REV	DATE	DESCRIPTION	APPROVED
7-01-2014	NO SCALE	DOUBLE DETECTOR CHECK	W-19B

CITY OF MERCER ISLAND
STANDARD DETAILS
WATER

Quotation - 6610 E Merc...

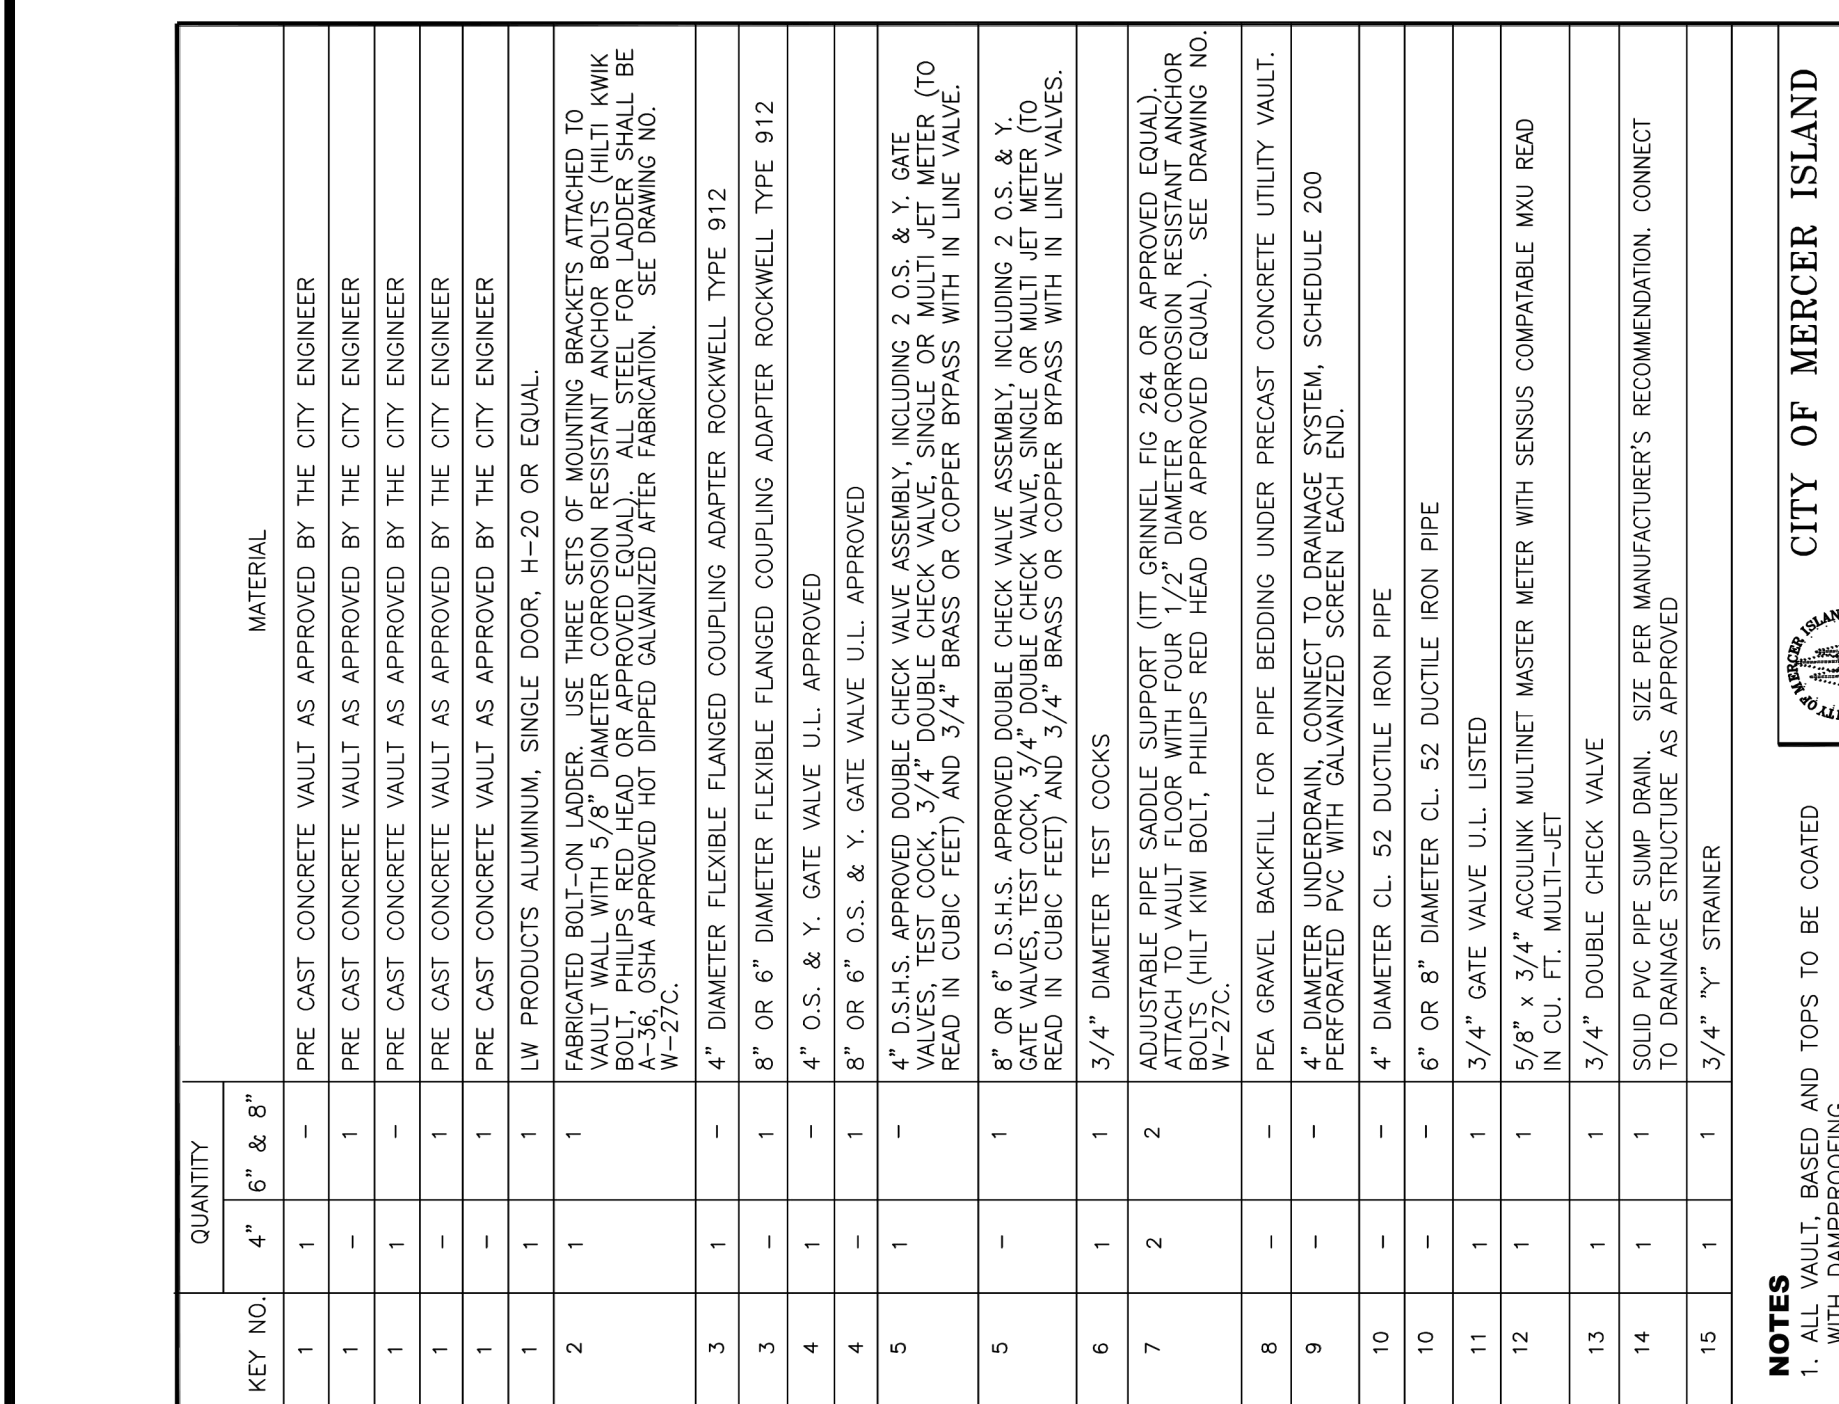
Newcastle recommends 6x8 vault
